ADDENDUM NO. 1

Date:	March 30, 2011
To:	Shortlisted Contractors
From:	Bob Anderson - Project Manager
Reference:	New Maintenance Facility – Great Salt Lake State Marina Division of Parks and Recreation – Magna, Utah DFCM Project No. 10029510
Subject:	**Addendum No. 1**

Addendum No. One
for the
Great Salt Lake Marina Storage Building
Bid Package No 1
DFCM Project No. 10029510
MHTN Project No. 2010546

EP-601-R1-1

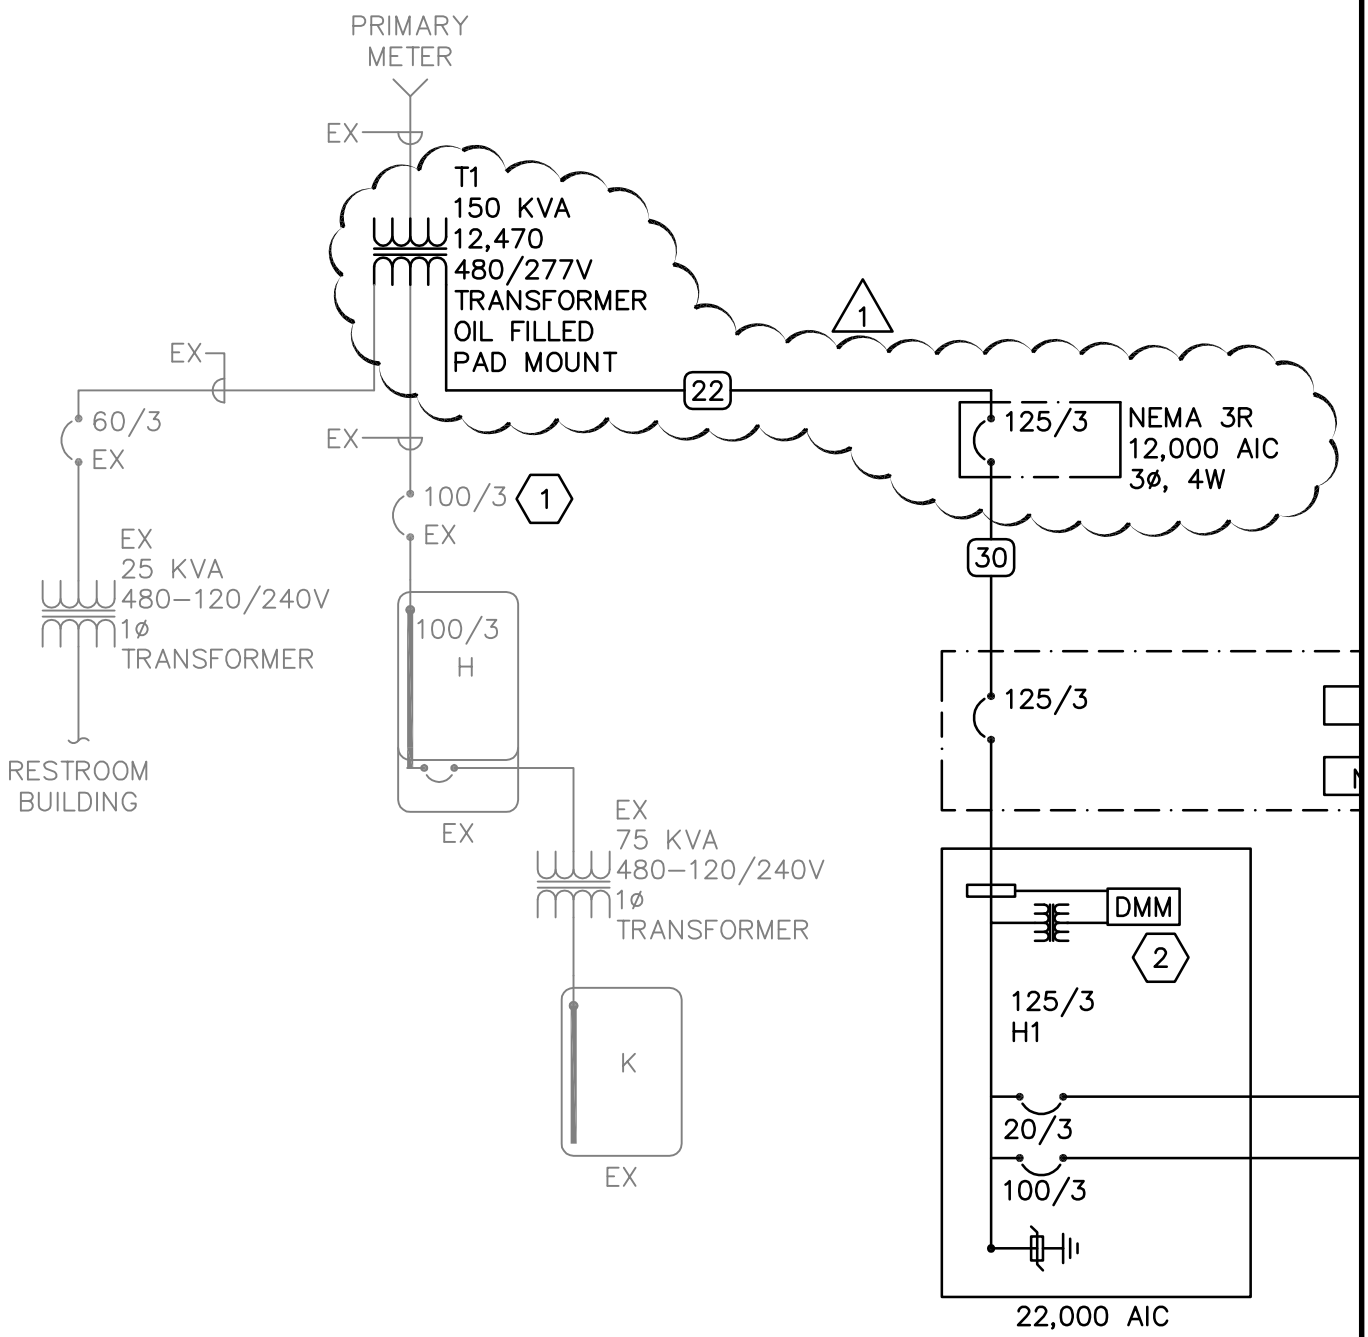
1. See attached sketches ES-101-R1-1, ES-101-R1-2 & ES-101-R1-3, EP-601-R1-1 & EP-601-R1-2 for new transformer and enclosed circuit breaker "CB" location.
   a. Contractor will replace existing medium voltage transformer with a new 150 KVA transformer.
   b. Provide a 125/3 amp 480 volt disconnect adjacent to transformer for feeder running to maintenance building.
   c. Transformer pad is for bidding purposes only. Coordinate size and opening with transformer see specification section 261200.
   d. SCC rating for transformer and enclosed circuit breaker "CB" should be 22,000 AIC or greater.
   e. Change the number for the feeder between "CB" at the new transformer, and MCB at the maintenance building to #30 from the conductor and conduit schedule (matches one-line)

1. PROVIDE A NEW 150 KVA, 12,470–480/277 VOLT TRANSFORMER. PROVIDE LUGS ON THE SWCONDARY SIDE WHICH WILL ALLOW THE CONNECTION OF THREE SERVICES (MAXIMUM SIZE PER SERVICE FEEDER IS 4/0 CU). REPLACE THE EXISTING 75 KVA TRANSFORMER. SCHEDULE OUTAGE WITH OWNER TWO WEEKS IN ADVANCE. 1
2. SEE PANEL SCHEDULES FOR BREAKER REQUIREMENTS.
3. INSTALL 125/3 AMP CIRCUIT BREAKER ADJACENT TO TRANSFORMER. 1

ES-101-R1-1

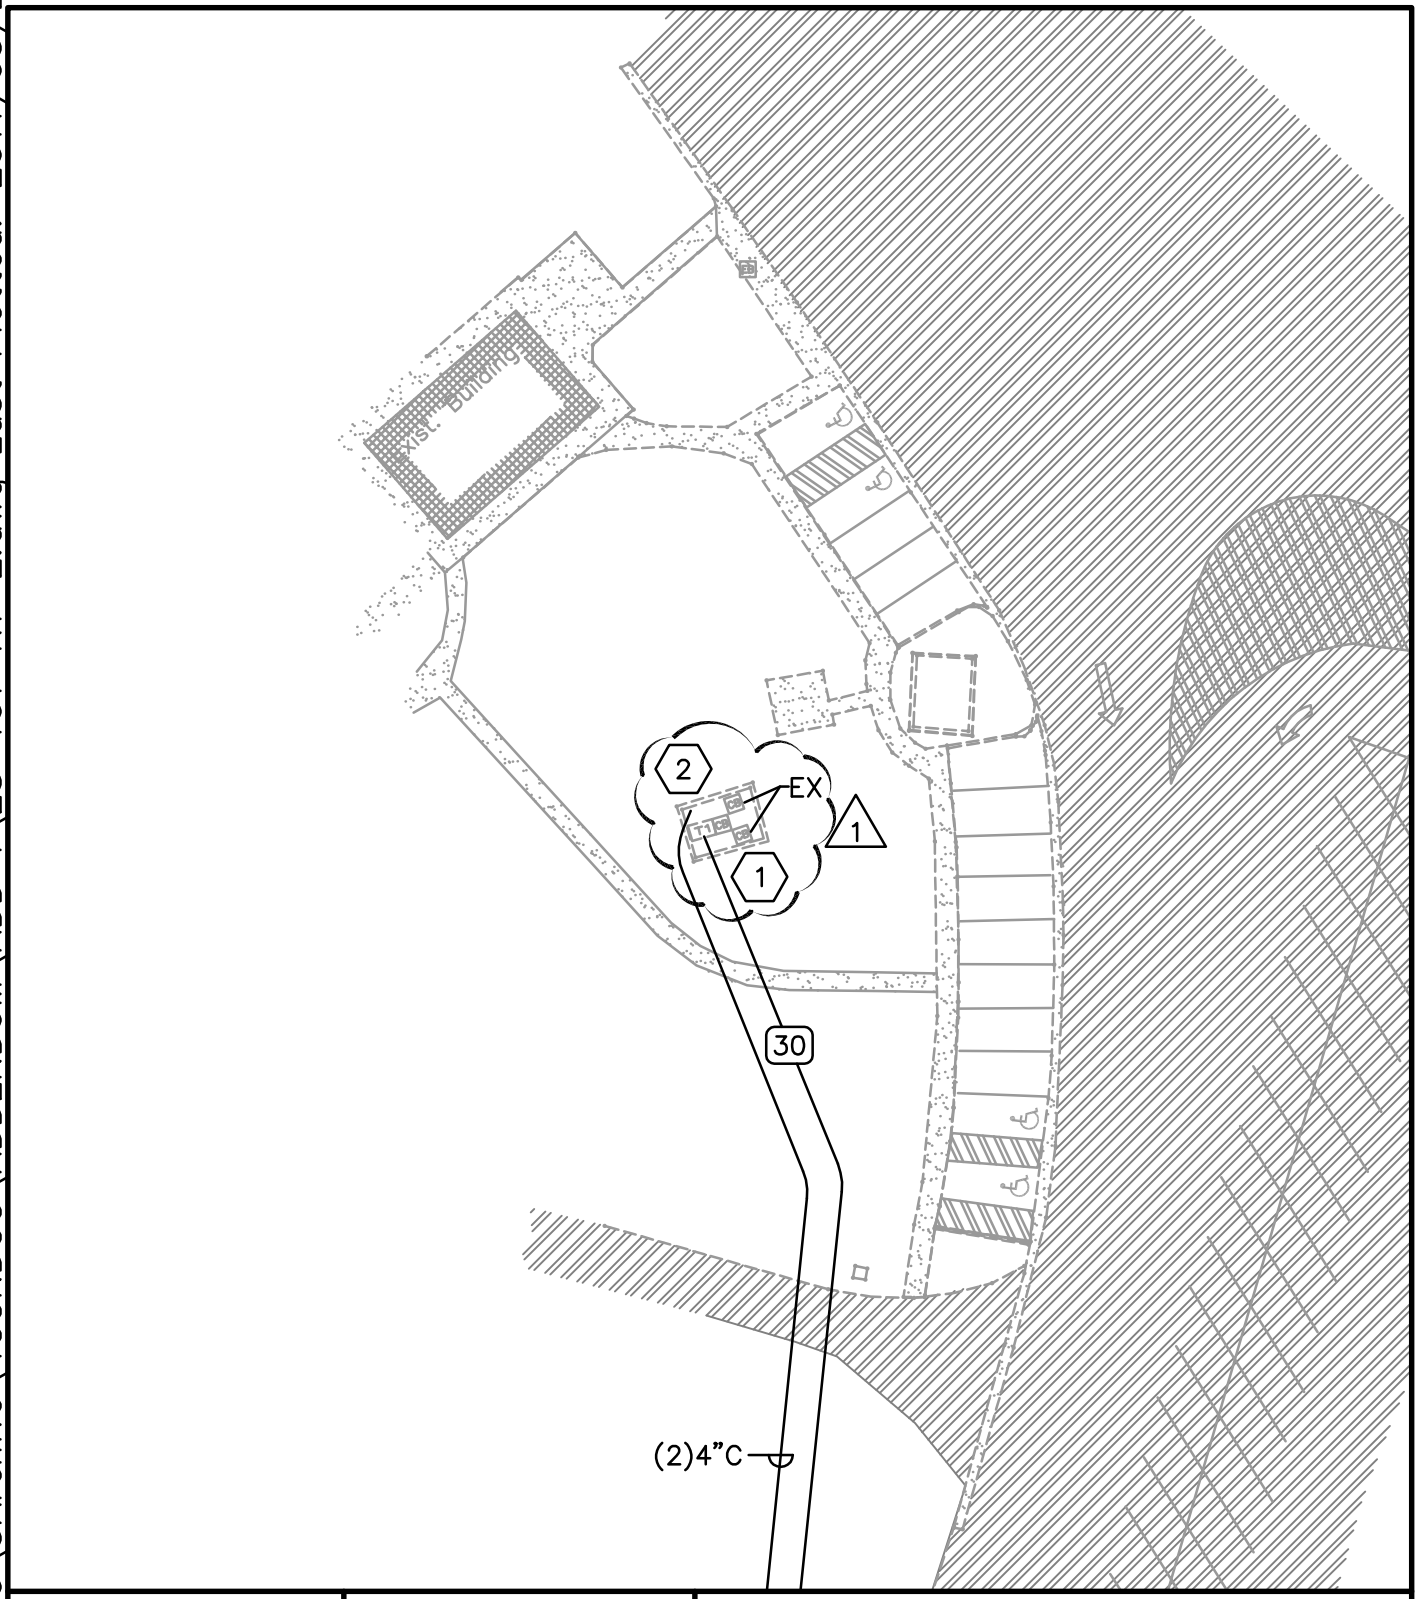
1. REPLACE EXISTING TRANSFORMER WITH A 150 KVA, 12,470–480/277 VOLT TRANSFORMER. RECONNECT THE TWO EXISTING 100/3 AMP BREAKERS TO SECONDARY SIDE OF TRANSFORMER. PROVIDE AN ADDITIONAL 150/3 AMP BREAKER FOR THE SECONDARY PROTECTION FOR THE FEEDER TO THE NEW MAINTENANCE BUILDING IN TRANSFORMER ENCLOSURE. ALL NEW ELECTRICAL GEAR IN ENCLOSURE MUST BE NEMA 3R. REPAIR ANY DAMAGE TO RAILROAD TIES SURROUNDING TRANSFORMER DUE TO CONSTRUCTION. 1
2. RUN TWO 4" CONDUITS FROM PHONE PEDESTAL TO PHONE BOARD. COORDINATE WITH QWEST COMMUNICATIONS.

ES-101-R1-3

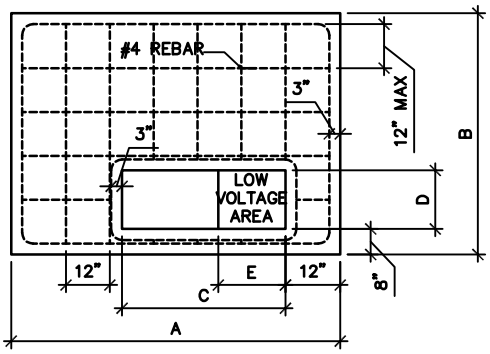
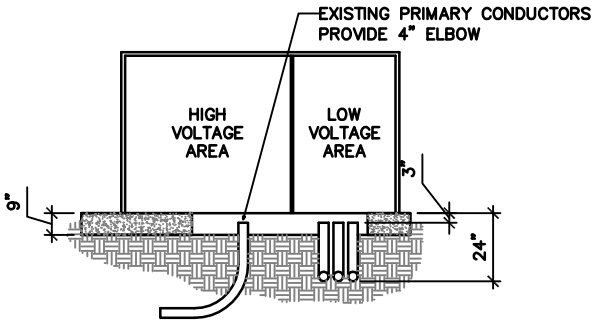
2 TRANSFORMER PAD DETAIL
